SAN FRANCISCO PLANNING DEPARTMENT

Addendum to Environmental Impact Report

Approval Date: May 15, 2013
Case No.: 2007.0347E
Project Title: Modified Project 7-3: Great Highway and Point Lobos Avenue
Bicycle Lanes
EIR: San Francisco Bicycle Plan
SCL No. 2008032052, certified August 4, 2009
Zoning: n/a, in public right-of-way
Block/Lot: n/a, in public right-of-way
Lead Agency: San Francisco Planning Department
Project Sponsor: San Francisco Municipal Transportation Agency
Kristiann Choy, Project Manager - 415.701.2493 - kristiann.choy@sfmta.com
Staff Contact: Monica Pereira – 415.575.9147 - monica.pereira@sfgov.org

STRIPING DRAWING
POINT LOBOS
EL CAMINO DEL MAR TO GREAT HIGHWAY

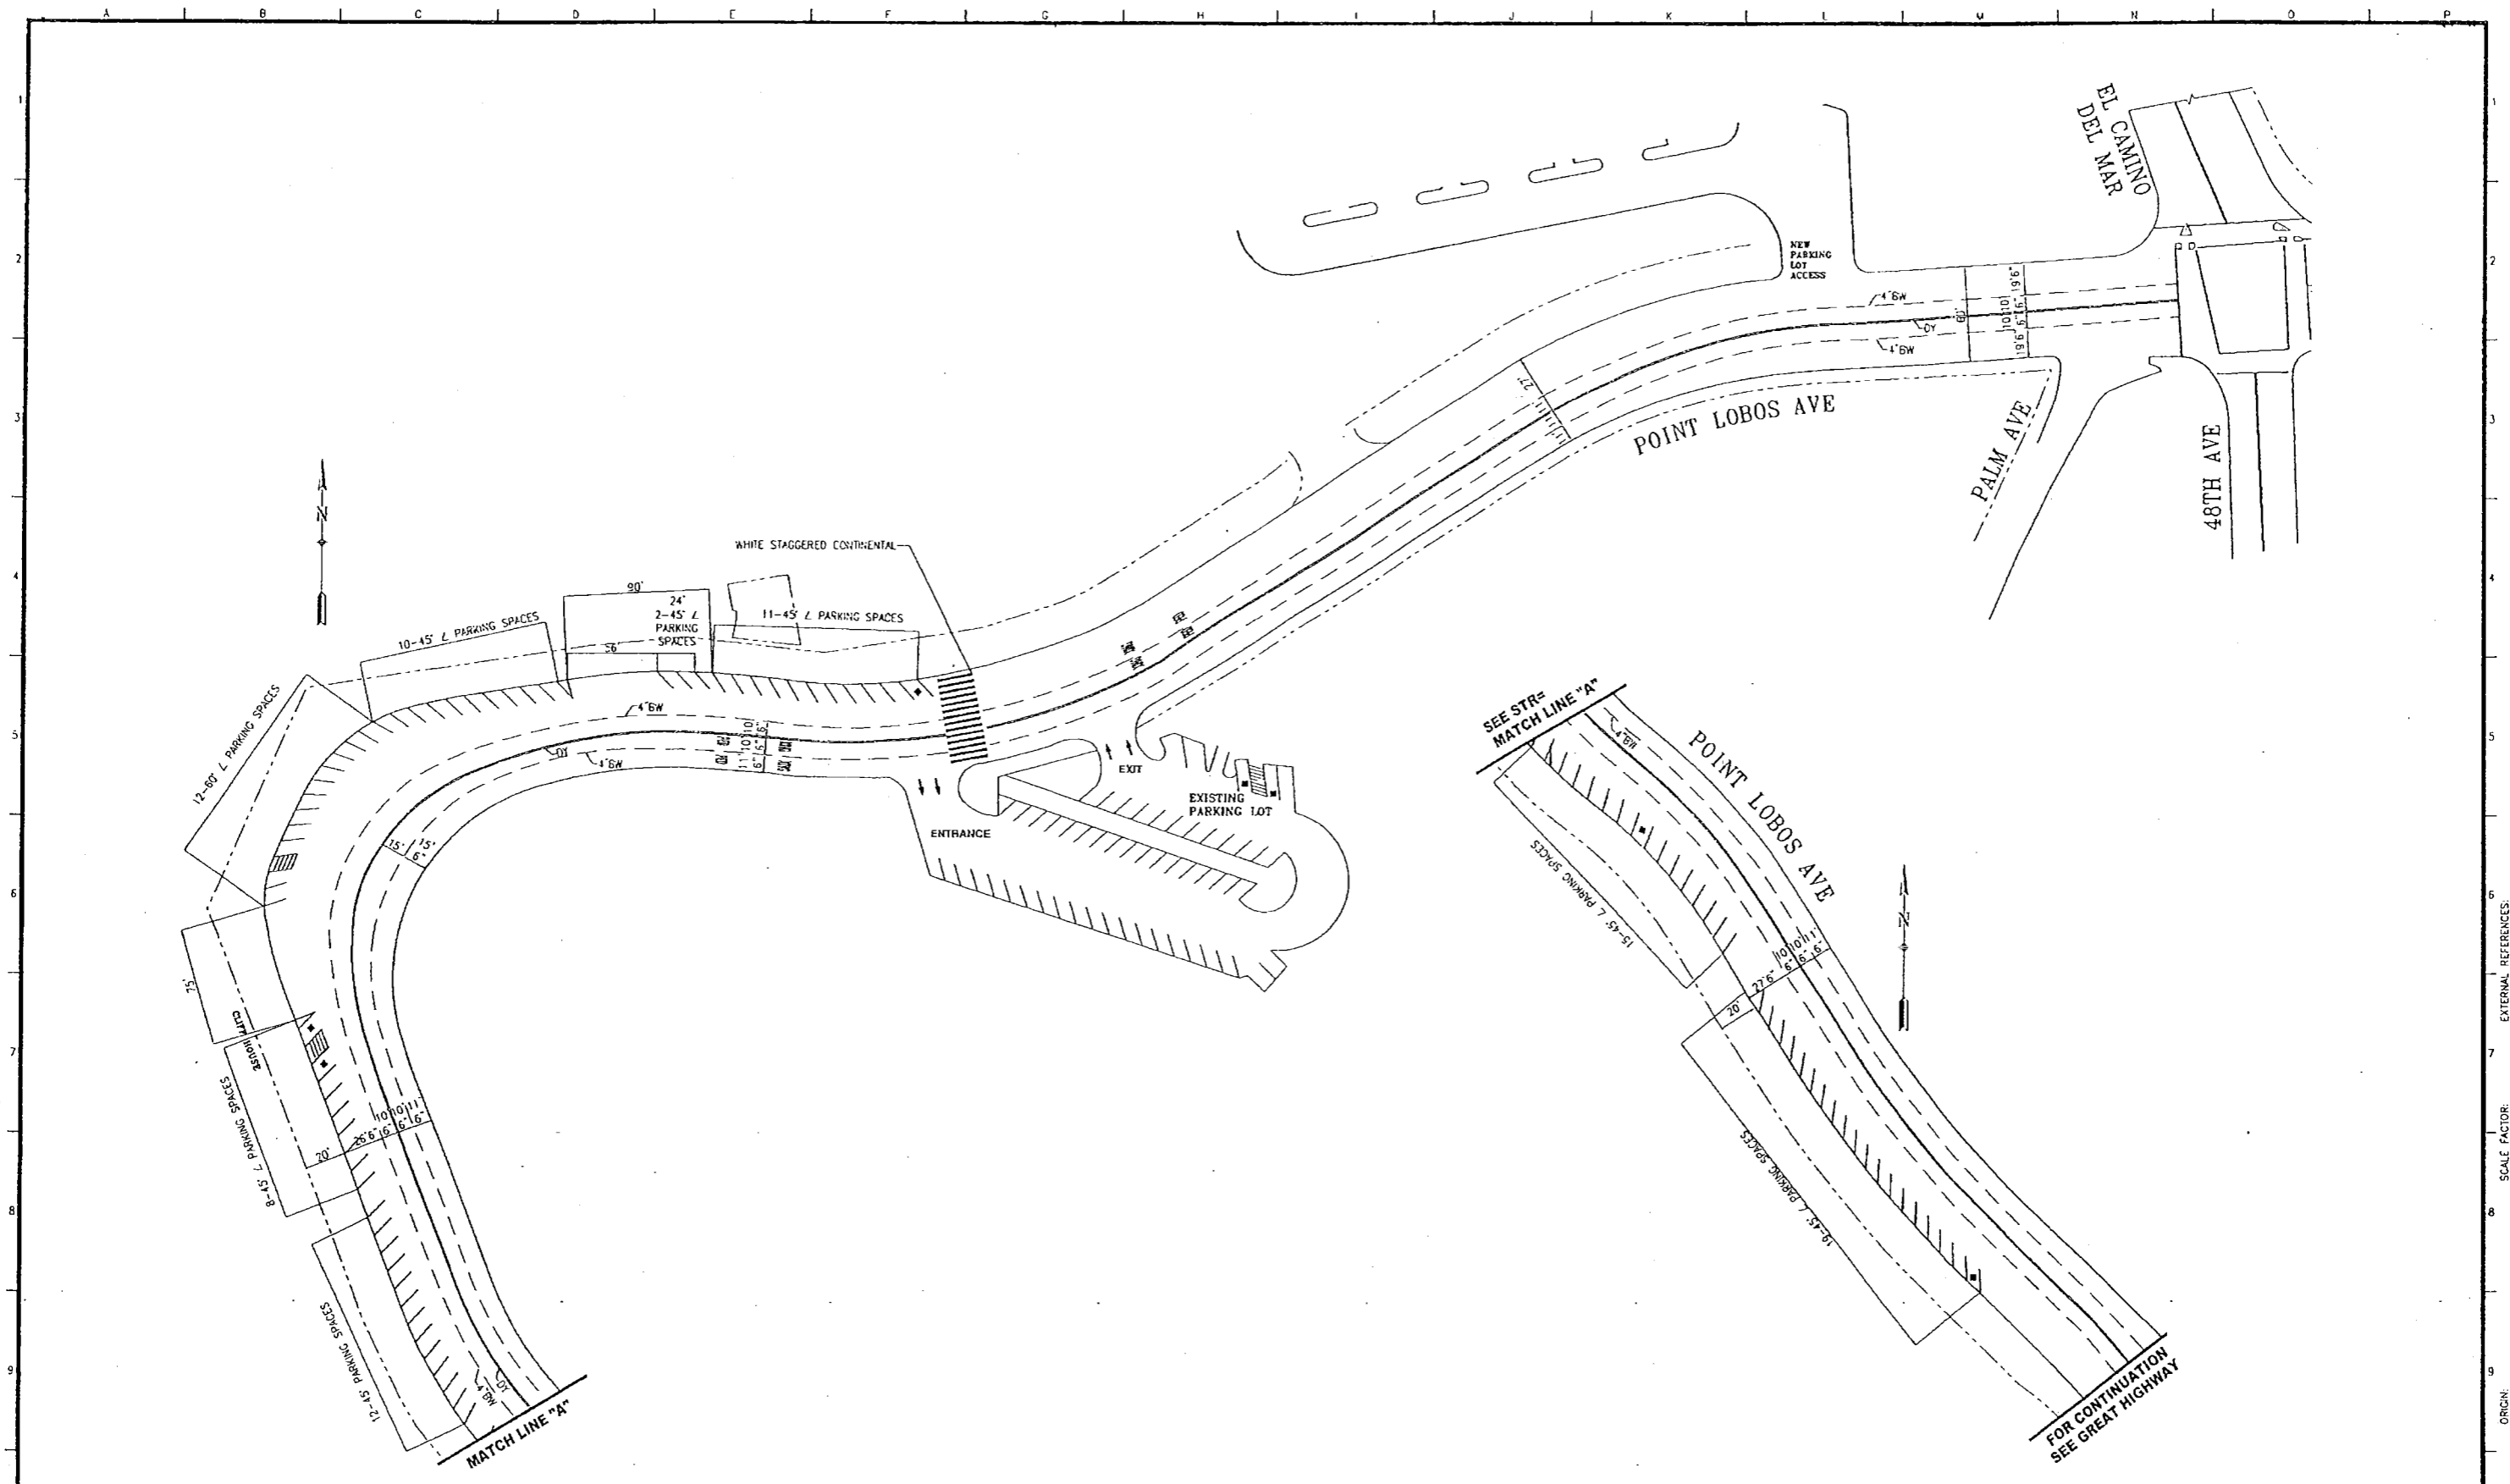
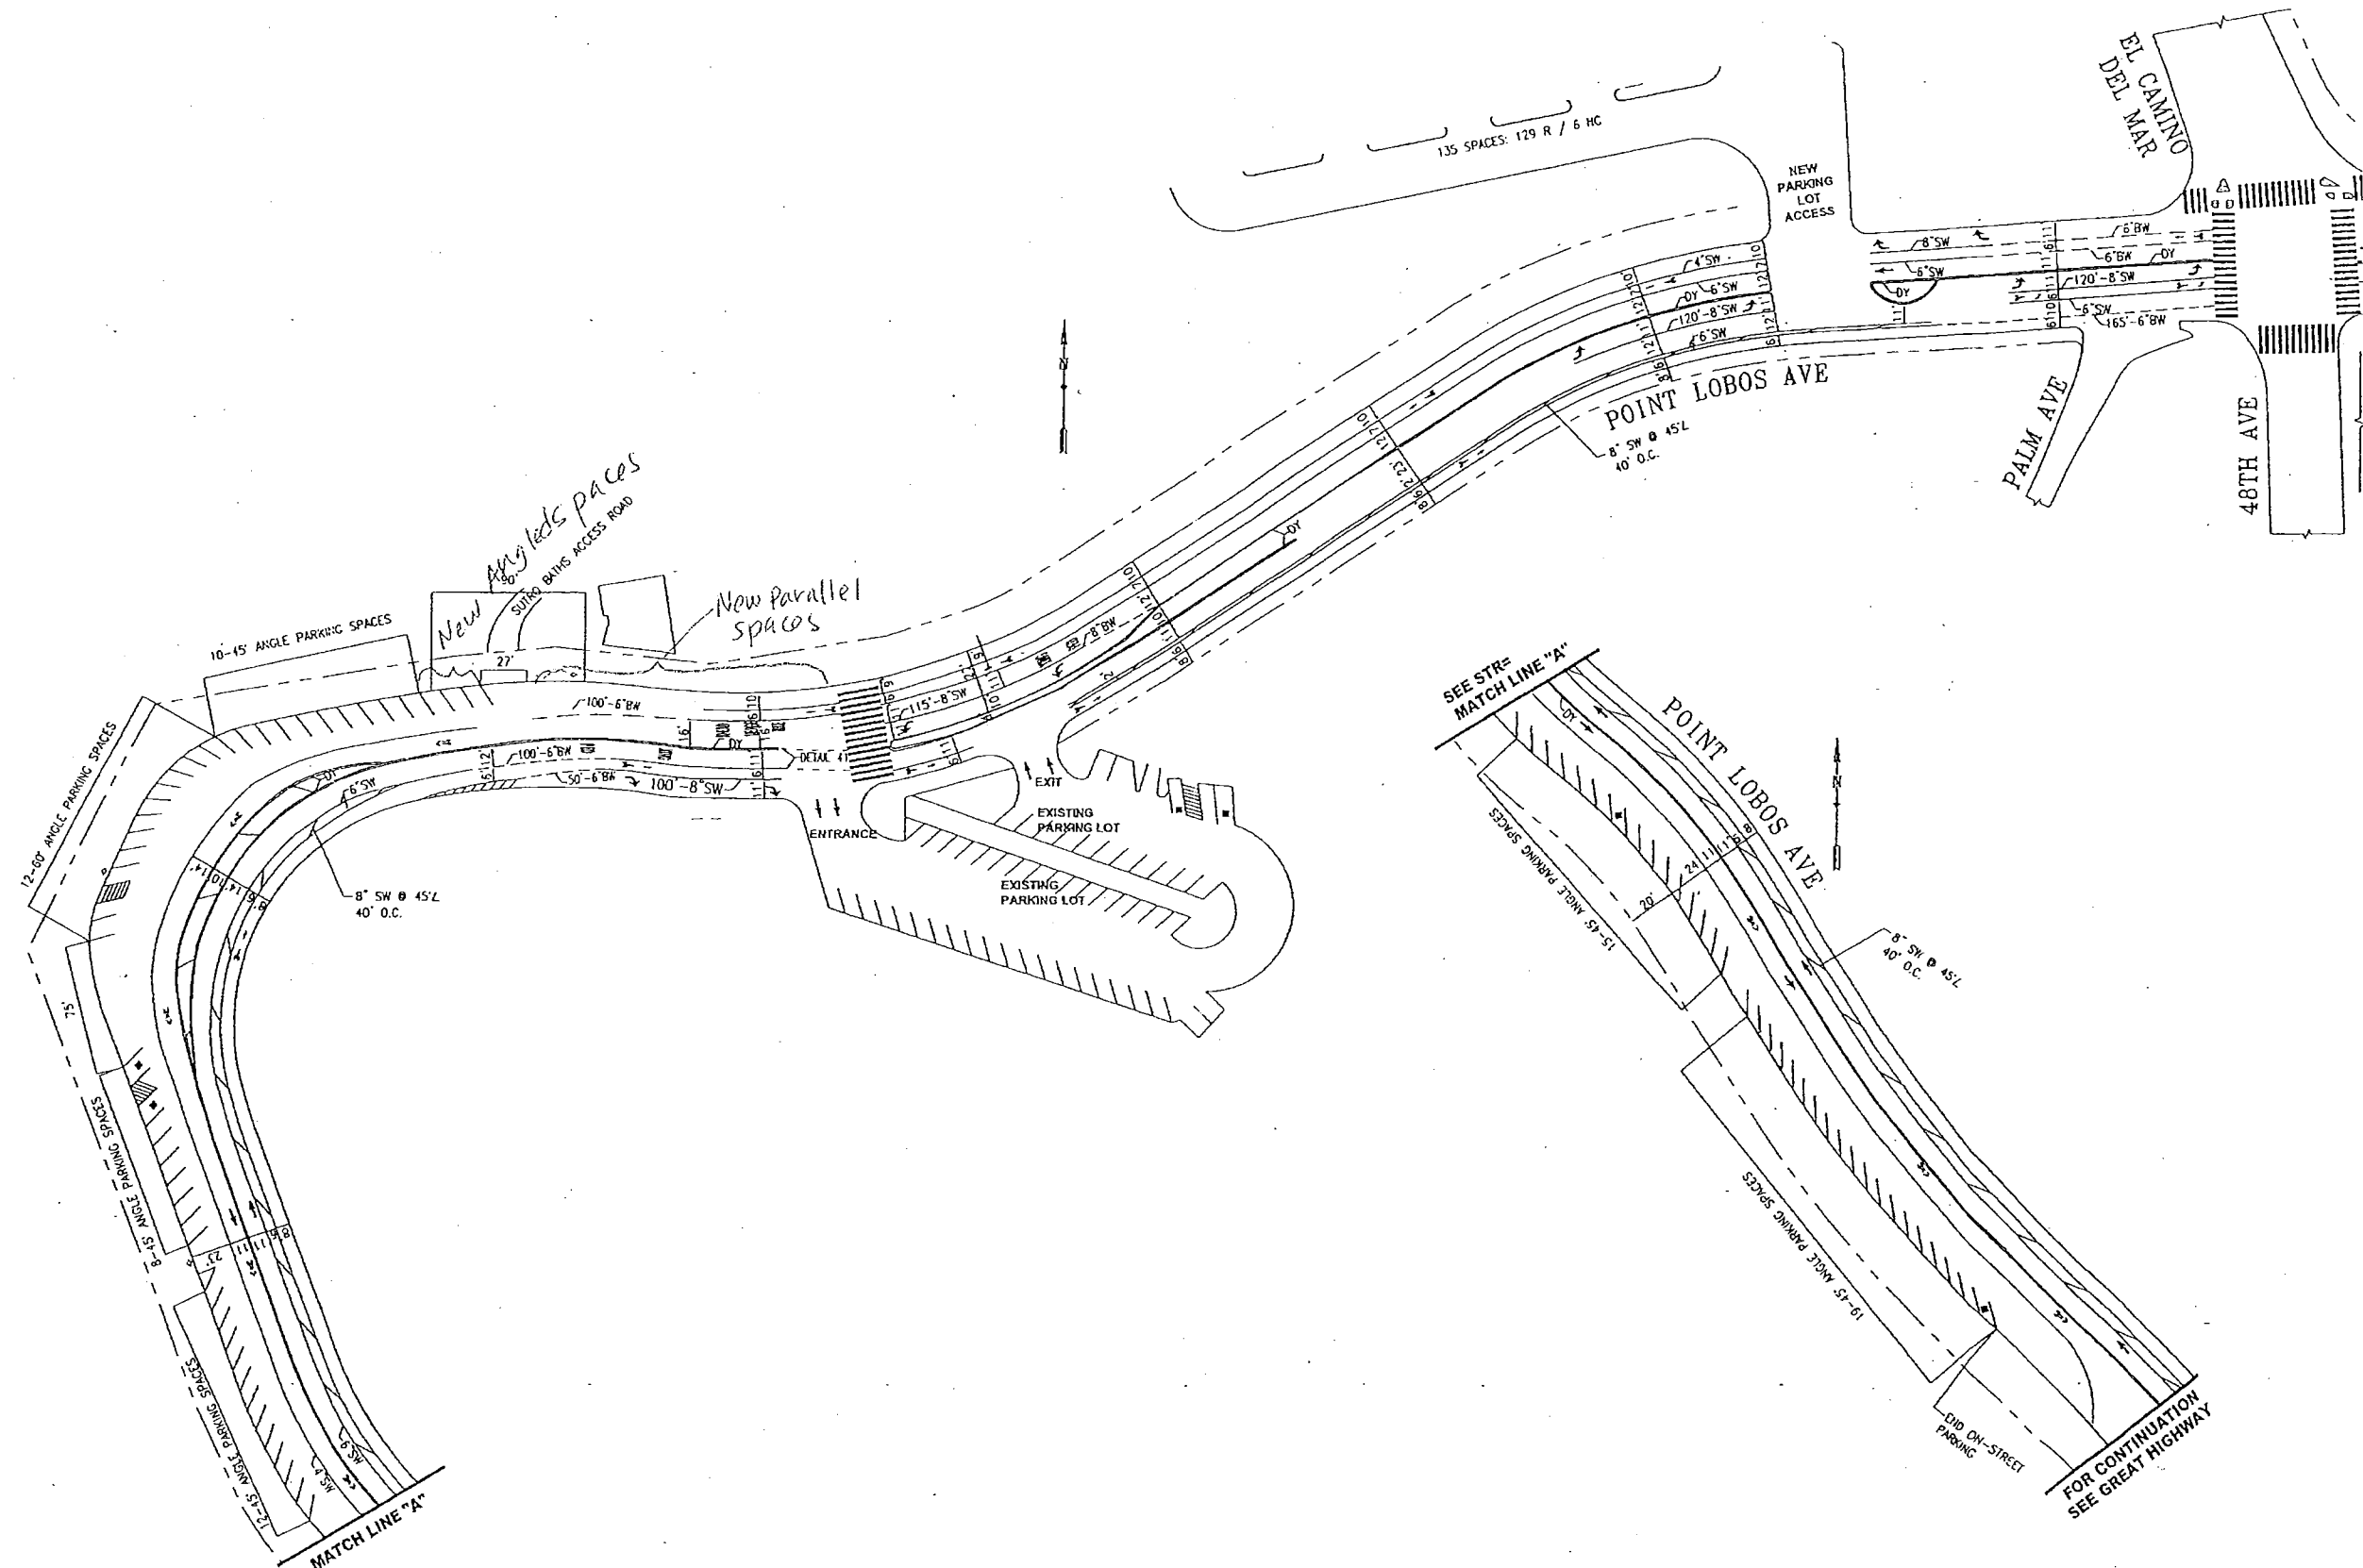
- Convert 13 angled parking spaces, located in front of 902 Point Lobos Avenue (west of 48th Avenue), to 8 parallel spaces and add 3 angled parking spaces to the west of these spaces.
